Economic Commission for Europe

Group of Experts on Road Signs and Signals

Twelfth session

Note by the secretariat

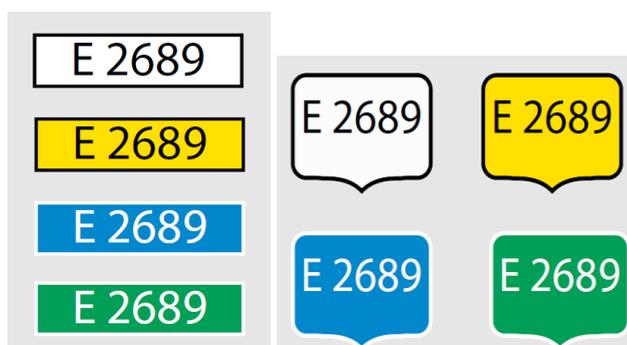
While Article 5, point 1 c (ii) distinguishes six “groups” of the G “sub-class” signs, two of these “groups” – road identification and place identification signs – are not mentioned again in the Convention, ie. there is no information in Annex 1 about them nor are the images of signs for these groups reproduced in Annex 3. This requires to be rectified.

In Annex 1, refer to “Road identification” and “Place identification” signs. Provide the corresponding images in Annex 3.

Signs [the appropriate sign codes eg. G, 10, G, 11 ... or G, 25, G, 26 ... to be inserted here once the sequence in G class as well as the number of these “new” road identification signs is determined] **are examples of road identification signs.**

The road identification signs shall consist of figures, letters or combination of figures and letters, or by the road name framed in a rectangular panel or a shield panel. For Contracting Parties using a specific route classification symbol, that symbol may be used instead of the rectangle or shield.

With the amendment accepted, the example images for road identification in Annex 3 sign will look as follows (only images with black inscription on light-colour ground (white and yellow) and white inscription on a dark-colour ground (dark blue and green) are provided; as such dark blue inscription and yellow inscription can also be placed respectively on light-colour and dark-colour grounds):

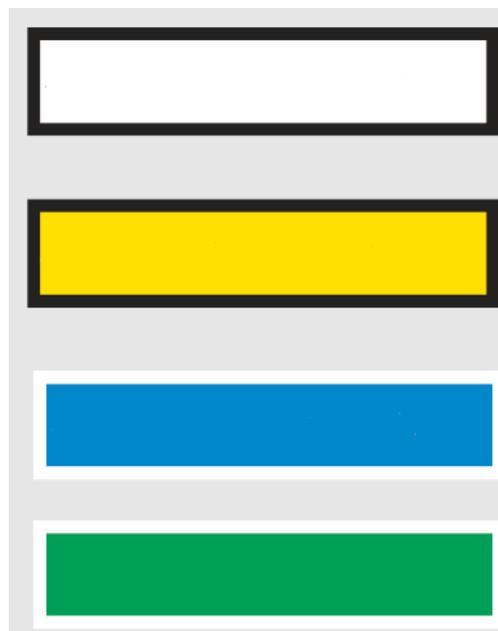
The place identification shall be in a shape of an elongated rectangle to make it differ conspicuously from the rectangular signs indicating the beginning and the end of a built-up area. Contracting Parties having chosen dark ground colour option for signs indicating the beginning and the end of a built-up area should choose a light ground colour option for the place identification sign and vice-versa.

With the amendment accepted, the example images for place identification signs in Annex 3 will look as follows (these images should include example inscription of a place in all the inscription colours permitted):

Some image examples for signs G, 3 a to G, 5 are shown below:

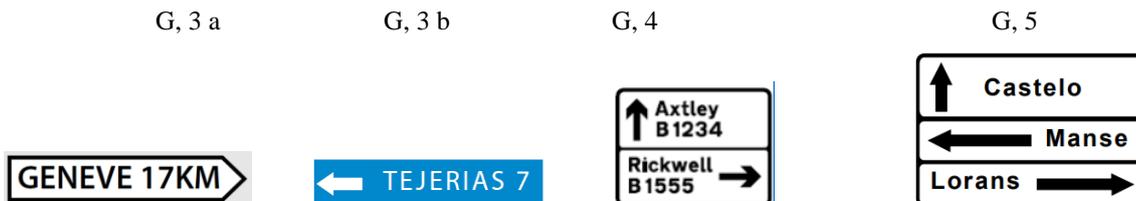
Annex I, Section G, points III.1 and III.2 refer to examples of direction signs in Annex III. There is need to provide more representative examples.

Point III.3 and III, 4 introduce signs that seem unnecessary in view of provisions included in Annex I, Section F, point I.2.

- (a) **Example of direction signs showing one direction: G, 3 a and G, 3 b**
- (b) **Example of direction sign showing two directions: G, 4**
- (c) **Example of direction sign showing three directions: G, 5**

G, 17:

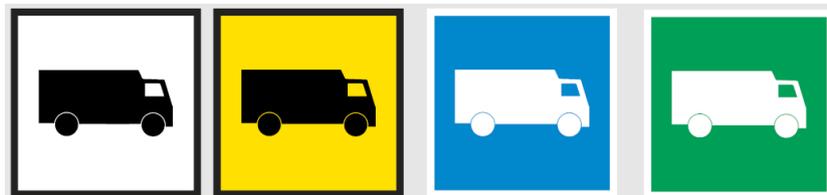
As for signs G, 17 through G, 21 (respectively points V.6 through V. 10) the colours of the ground and symbol should be decided and new text added as appropriate. The below images show the signs G, 17 through G, 21 should all ground colours of G section sign be permitted. These images are shown to facilitate the decision on colours that should be permitted for those signs.
